From: Singal, Balwant
Sent: Tuesday, November 18, 2014 11:11 AM
To: Harrison, Albon (awharrison@STPEGS.COM)
Cc: Stang, John
Subject: STP Risk-Informed Approach to Resolution of GSI-191 - Draft Request for Additional Information (Second Round) - TACs MF2400 and MF2401
Attachments: MF2400-Draft-RAIs-Second Round.docx

REQUEST FOR ADDITIONAL INFORMATION (RAI)

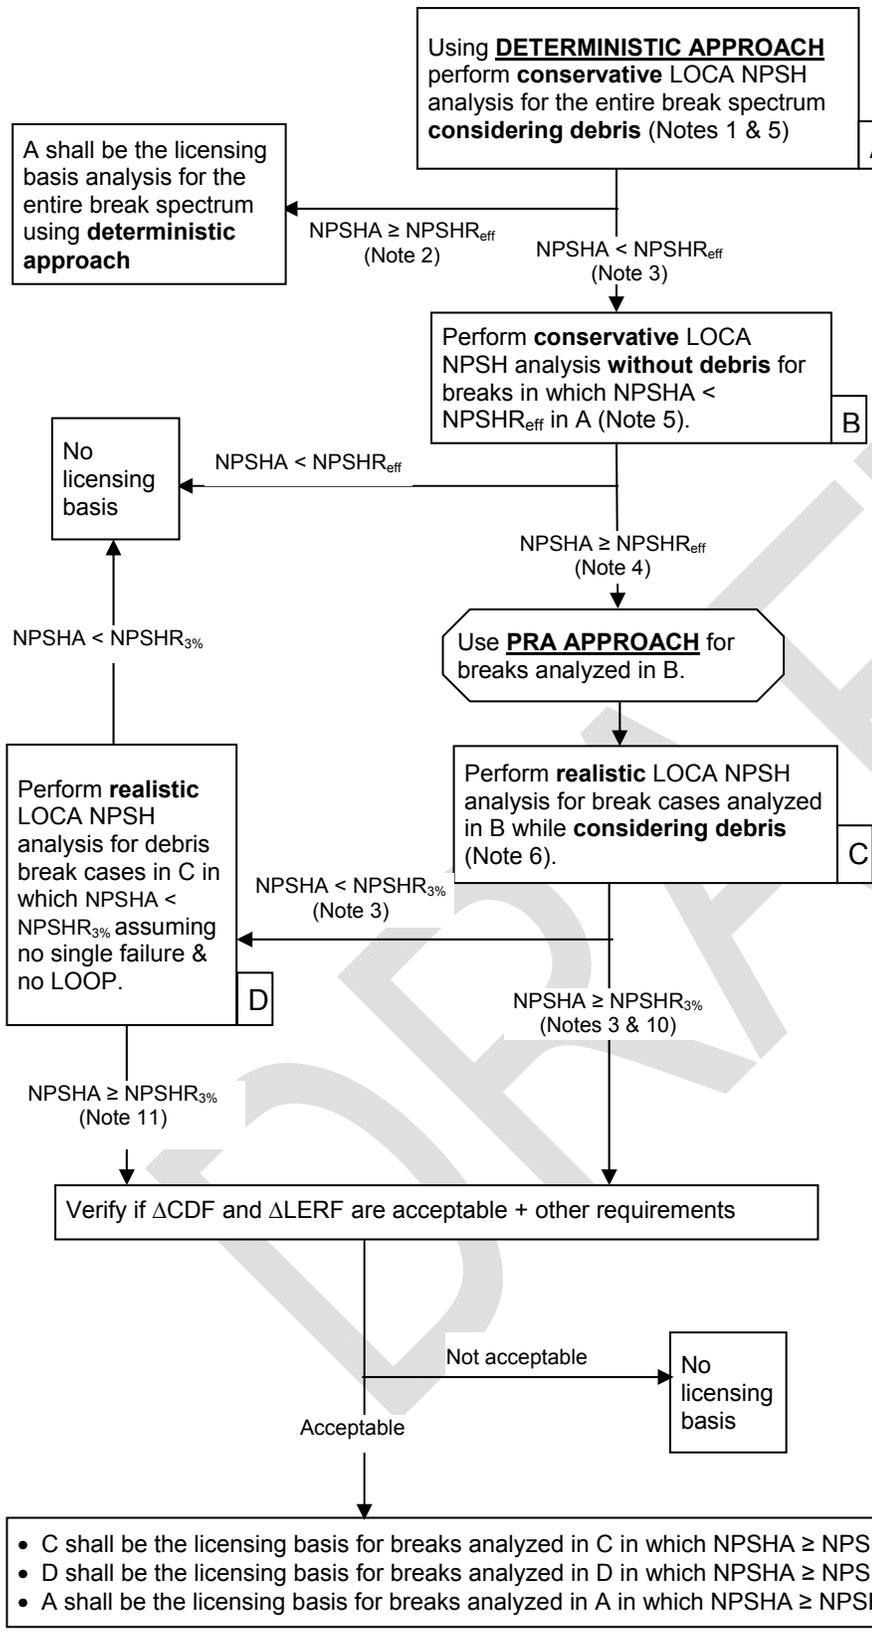
- (a) Refer to the table of major qualitative differences, for the subject "Sump Pool Treatment", please explain what is meant by: "No decay heat added. Mass and energy subtracted from the pool based on RELAD-3D instructions"
- (b) Refer to the table of major qualitative differences, for the subject "Pipe break mass/energy source", please explain what is meant by: "Communicated from RELAP5-3D via coupling interface as problem time progresses. The source is split by MELCOR into part liquid water, part steam, and part "fog"
- (c) Refer to the table under the heading "Summary Comparison of Main Parameter Values", please provide the basis for selecting the RELAP-3D/MELCOR values of the parameters in the table below and how are they determined:

- (d) Refer to the table under the heading “Summary Comparison of Main Parameter Values”; for the CONTEMPT and RELAP-3D/MELCOR analysis, please provide the basis for using different values of (1) thermal conductivity of concrete, (2) thermal conductivity of stainless steel, (3) specific heat capacity of concrete, (4) specific heat capacity of stainless steel, and (5) density of stainless steel.
